CITY OF ALBUQUERQUE

**Re: Sandia Lab FCU
1100 Rio Grande Blvd NW
Traffic Circulation Layout
Engineer's Stamp Date 12-15-2020 (H13-D109)**

**RE: SANDIA LAB FCU
1100 RIO GRANDE BLVD NW
TRAFFIC CIRCULATION LAYOUT
COMMENTS DATED: NOVEMBER 17, 2020**

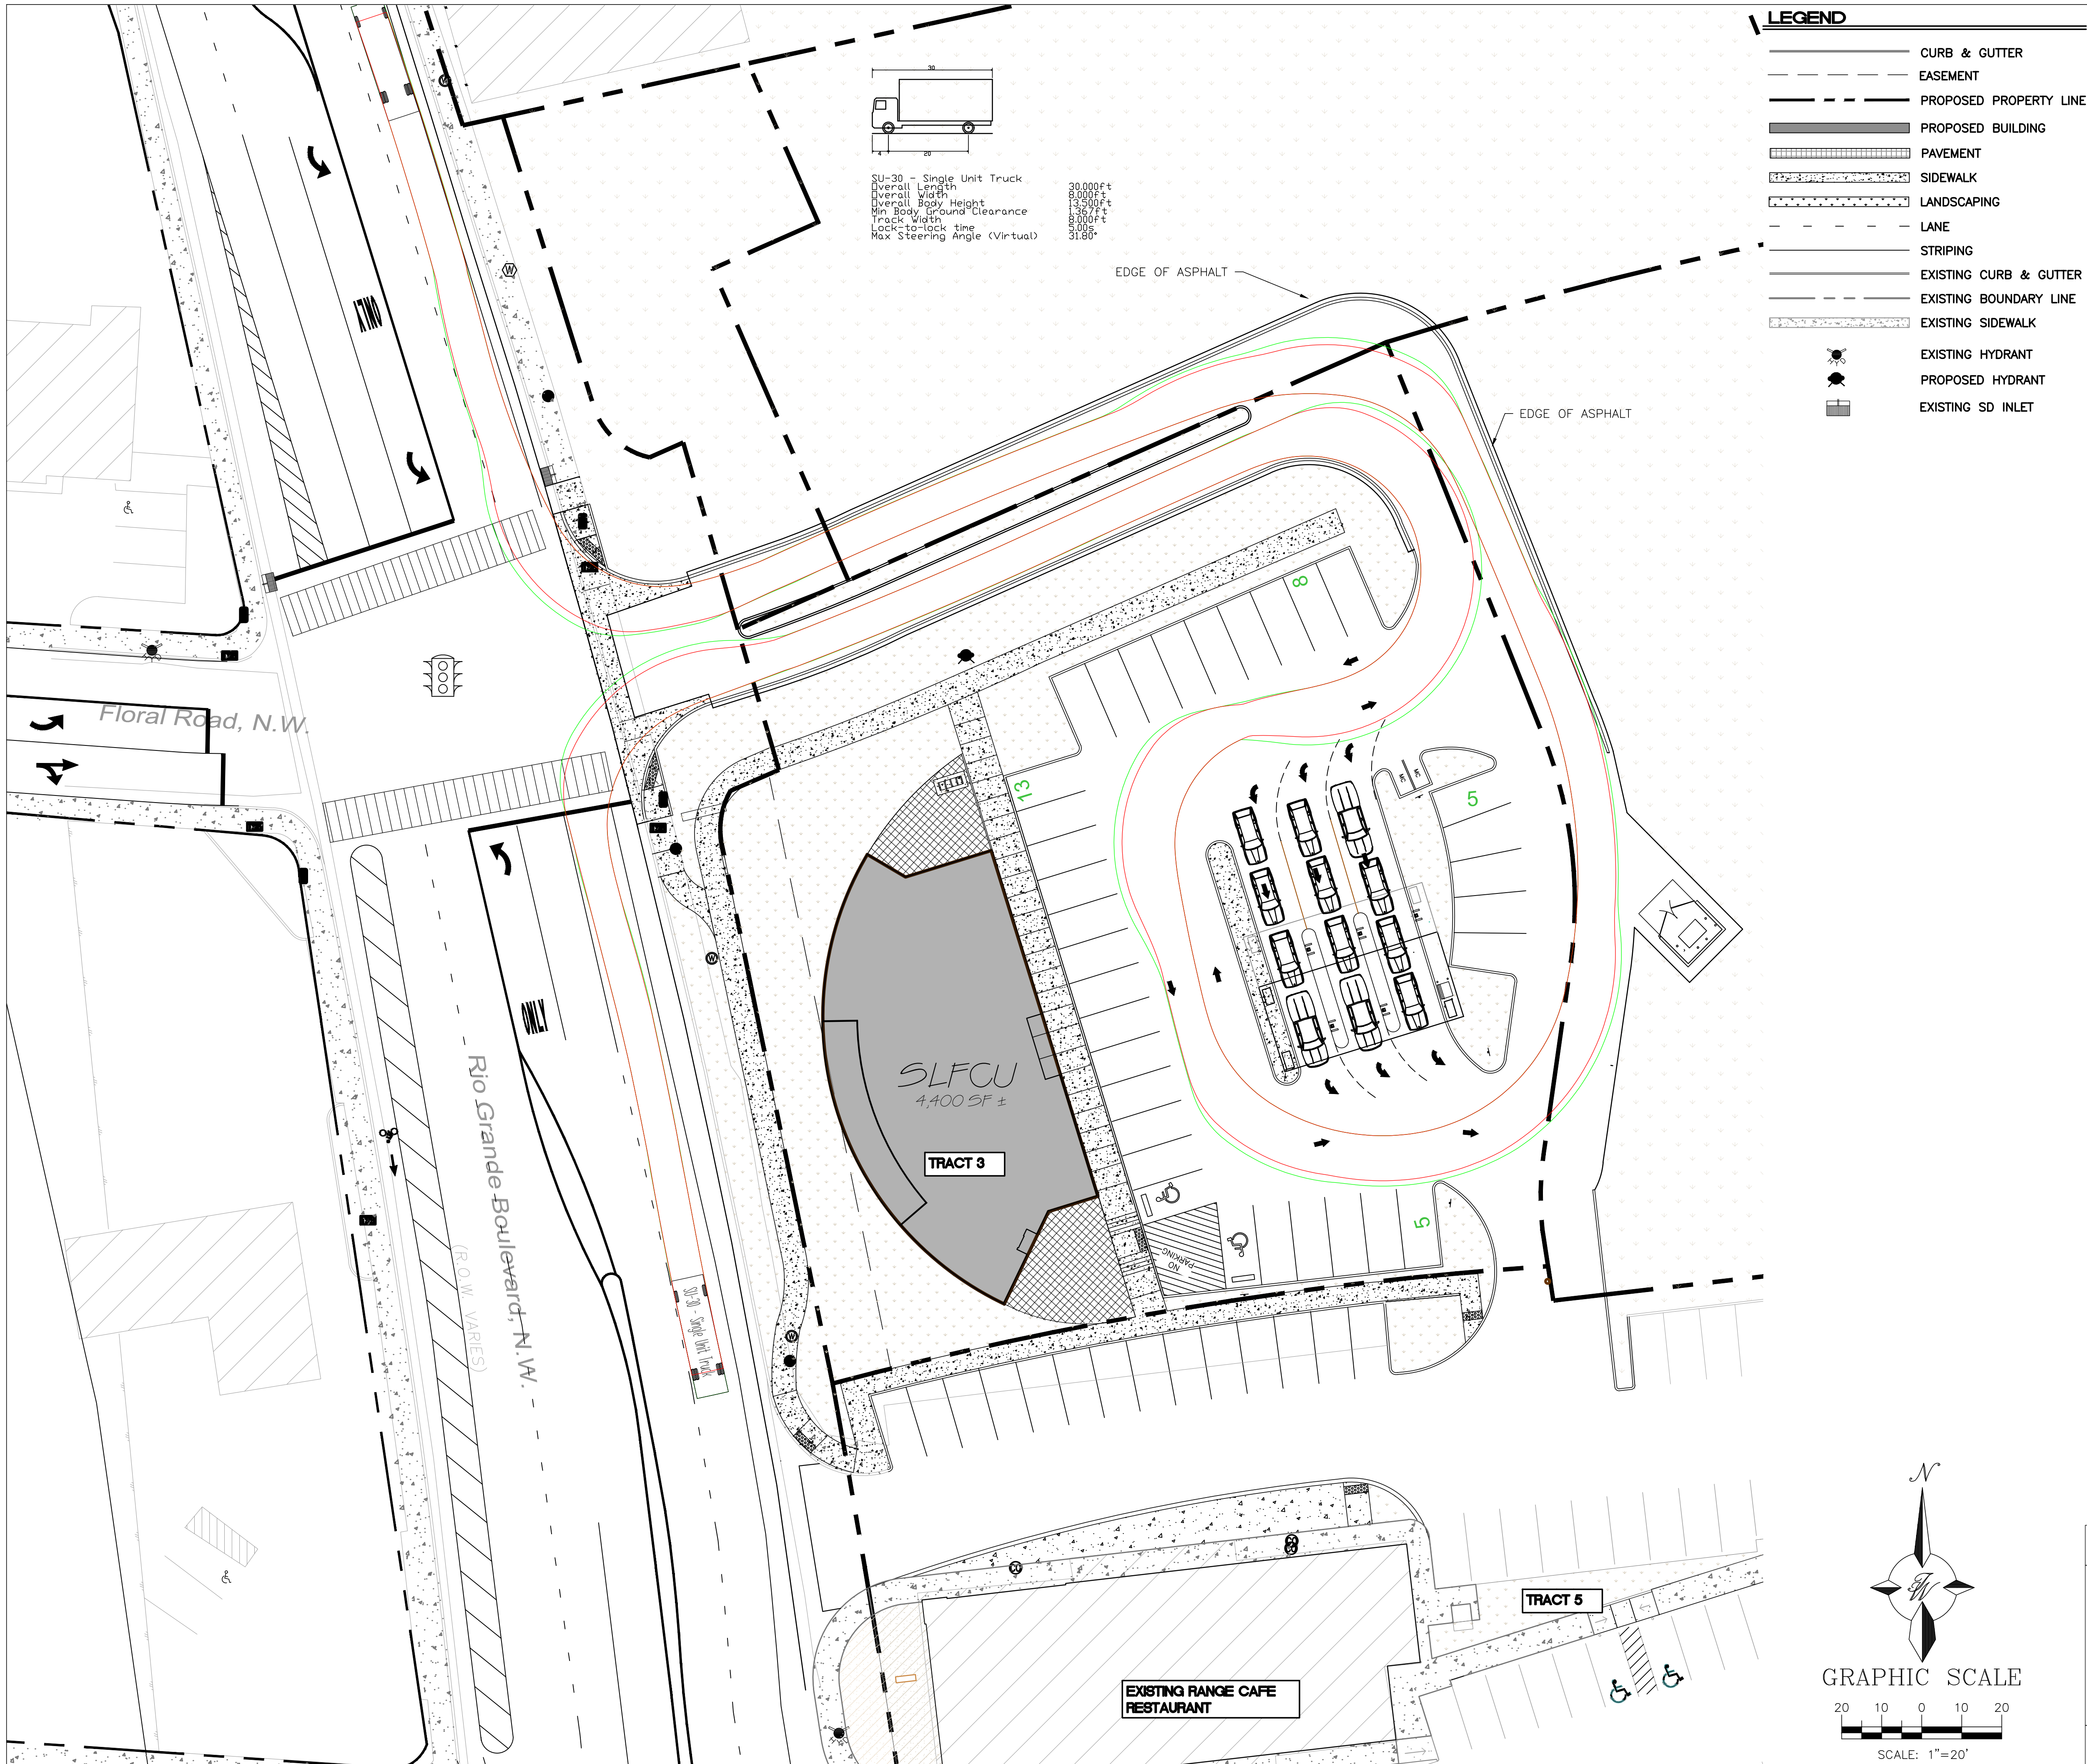
11. Entrance access: is 12ft adequate enough to handle any delivery / Refuge vehicles entering and existing for its temporary condition? Verify.
Response: See sheet E4 Truck turning exhibit, lane widths were updated accordingly. Design vehicle used was SU-30 per DPM.

FIGURE 7.4.62 Design Chart Flexible Pavements

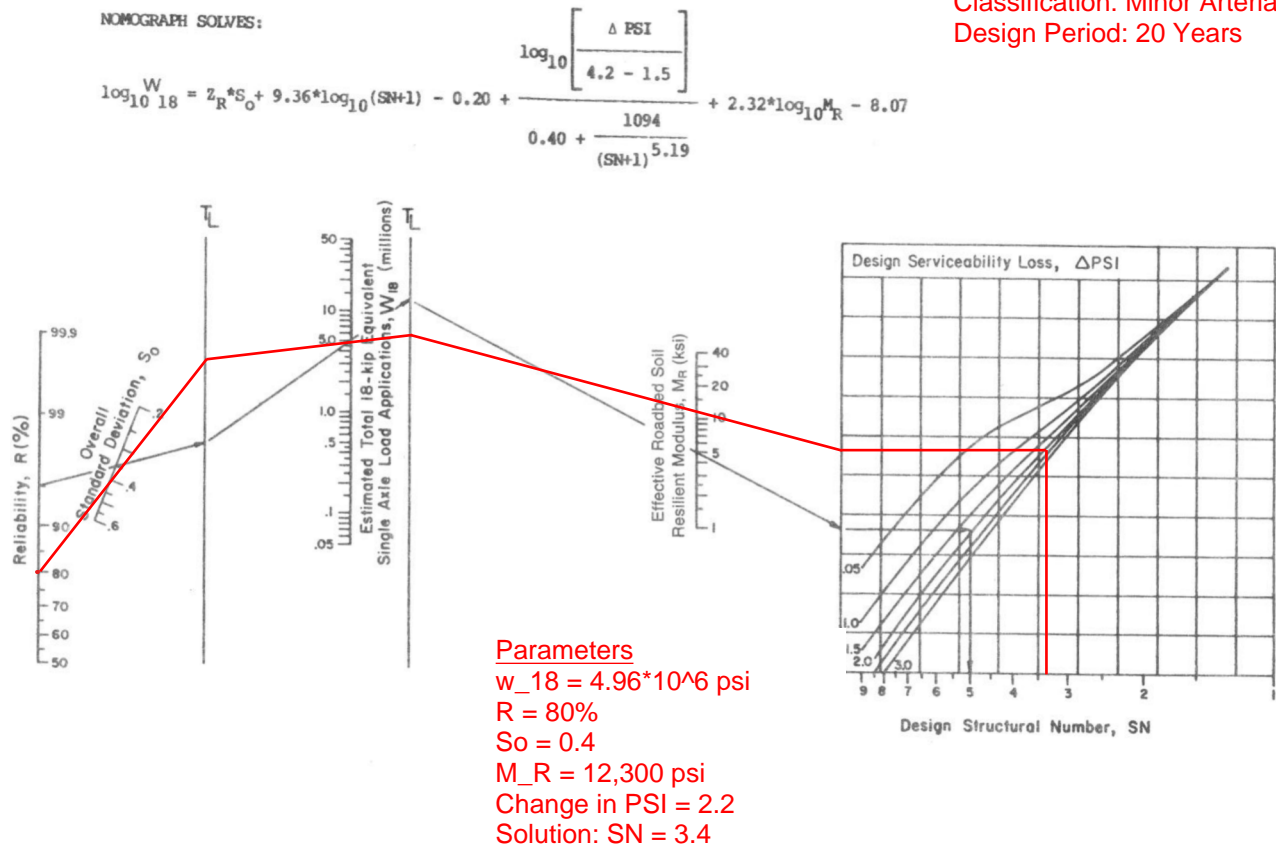
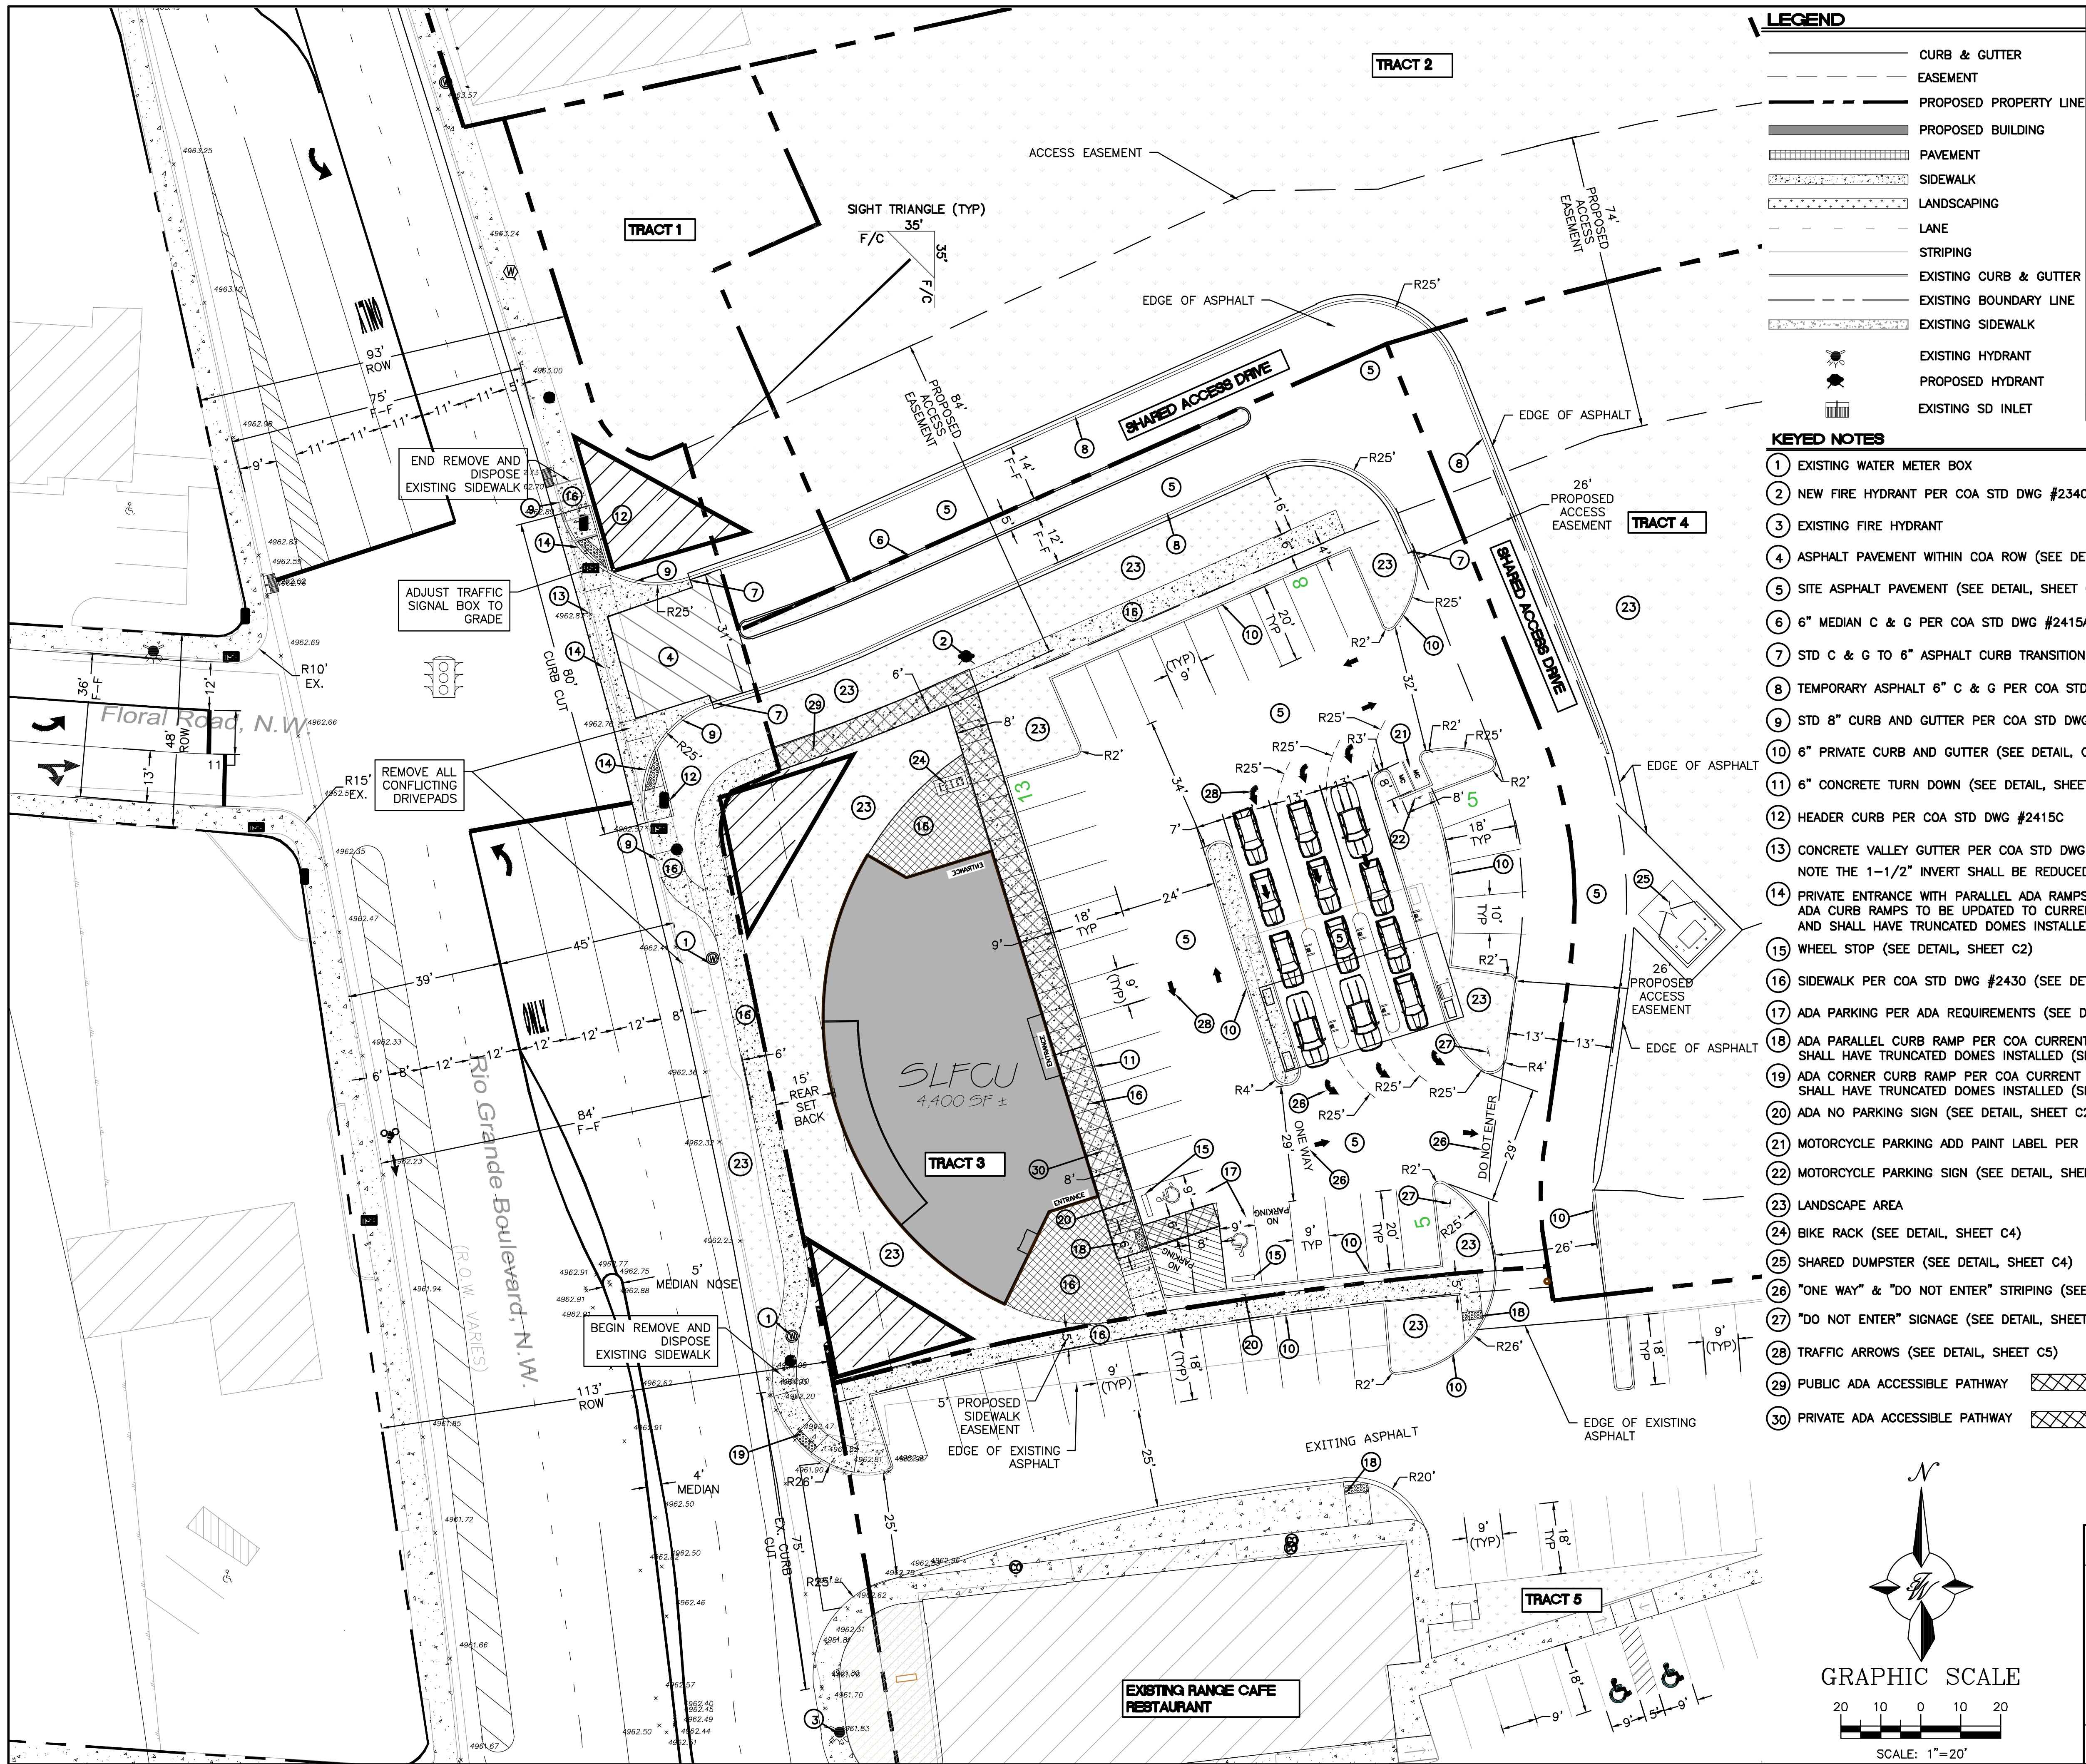
22. Limits of proposed asphalt pavement within COA ROW will need to follow COA DPM and standards with R value (min) 50. Show these limits

Response: See attached pavement design calculations. Design SN = 3.4.

Paving within proposed Rio Grande ROW will include 5" Asphalt on 6" Aggregate base on 12" subgrade. See keyed note #4 and detail on sheet C2.
